**CREST VIEW SUBDIVISION, FIRST ADDITION,**  
**RESUBDIVISION OF LOT 16, BLOCK A**

***Revised for the July 16, 2009 meeting***

APPLICATION NUMBER 3 DATE July 16, 2009  
Crest View Subdivision, First Addition, Resubdivision of Lot 16,  
APPLICANT Block A  
REQUEST Subdivision

## DETAIL SITE PLAN

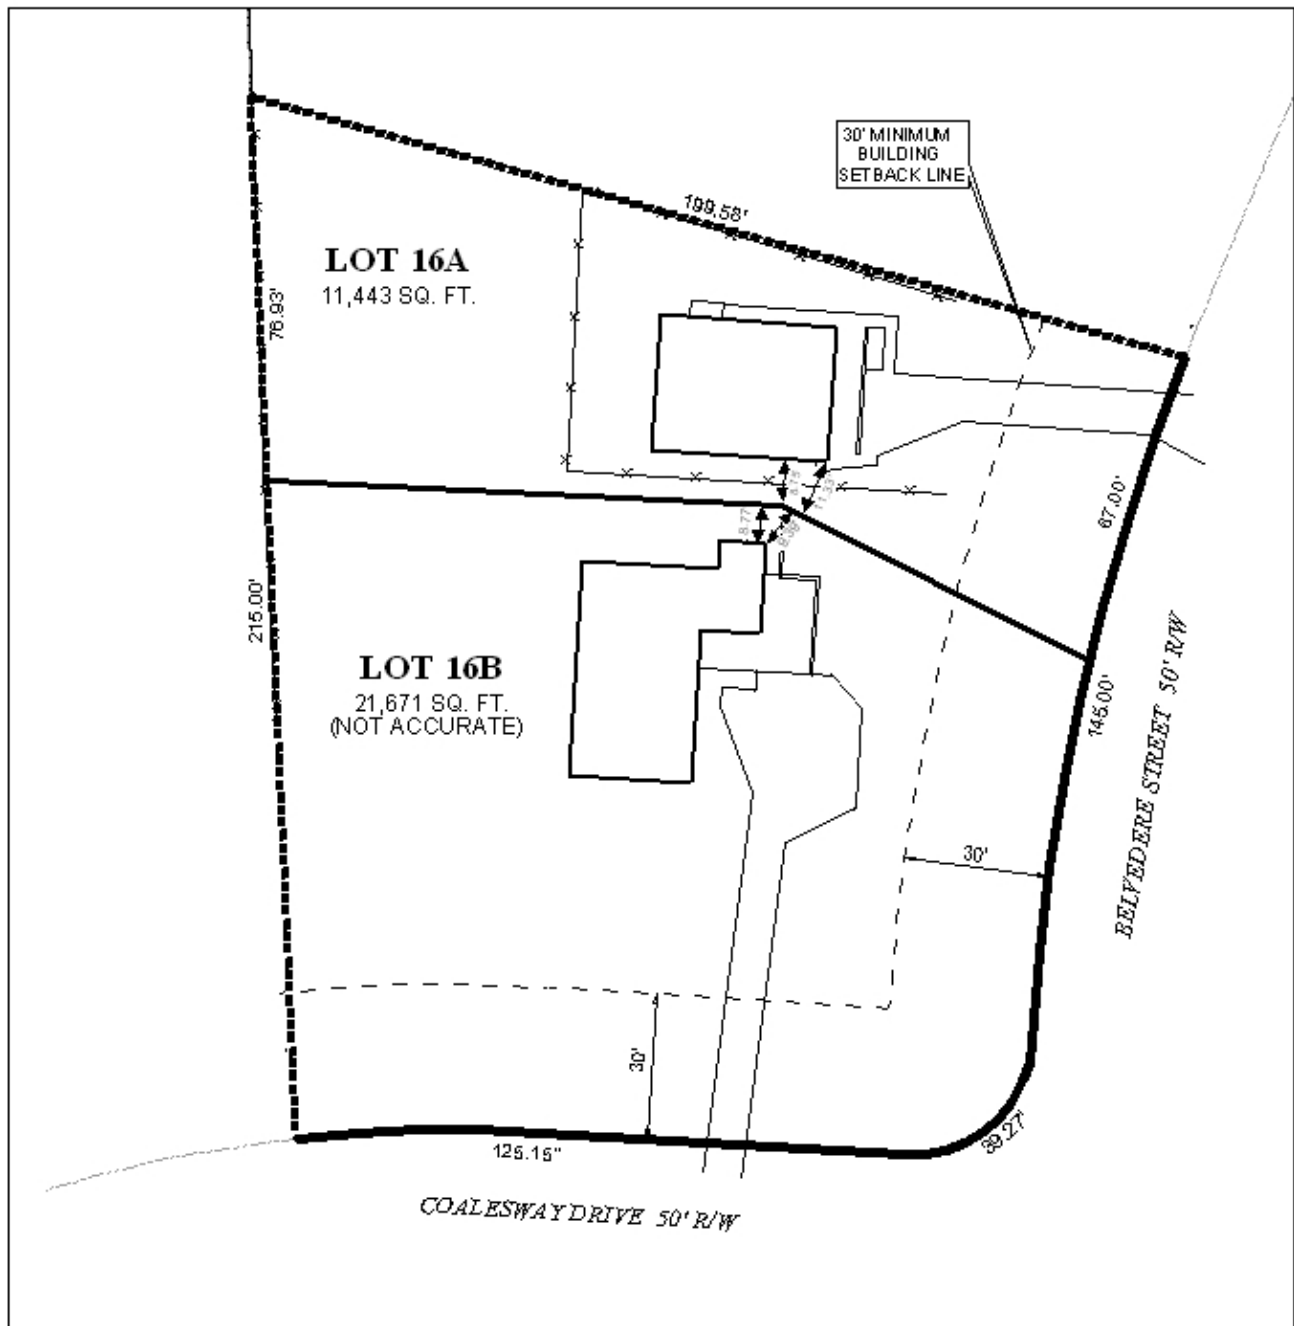
*The applicant has submitted a revised preliminary plat. The revised plat now indicates an 11,443 square-foot lot and a 21,671 square-foot lot. The plat also depicts both lots as being of adequate width to meet the standards of Section V.D.2 of the Subdivision Regulations. The new lot configuration also resolves the zoning violations that the old configuration created, namely a reduced side yard setback. Also depicted is a proposed 30-foot minimum building setback line.*

*It should be noted that there appears to be a discrepancy in the indicated lot size for the proposed Lot 16B. The original submittal indicated the lot with a size of 21,671 square feet. The new submittal indicates the lot being the same size as was indicated in the previous submittal, however, the size and dimensions of the lot have clearly changed. Thus, this should be corrected.*

*The plat nominally meets the minimum standards of the Subdivision Regulations for size and frontage. However, as noted previously, this subdivision application is the direct result of a zoning violation and will function to legalize an illegal conversion of a garage into a dwelling unit.*

*Further, the proposed lot that the converted garage will be on, proposed Lot 16A, will be vastly smaller and will have less street frontage than the other lots in this subdivision. Therefore, it would seem that the lot does not meet the standards of Section V.D.1 of the Subdivision Regulations which states, in part, "The size, width, depth, shape, and orientation of lots and the minimum building setback lines shall be compatible and appropriate to the location of the subdivision and the type of development and use contemplated." With that being stated, it would seem that this subdivision would be inappropriate.*

- 1) Does not comply with Section V.D.1 of the Subdivision Regulations regarding compatibility and appropriateness.*
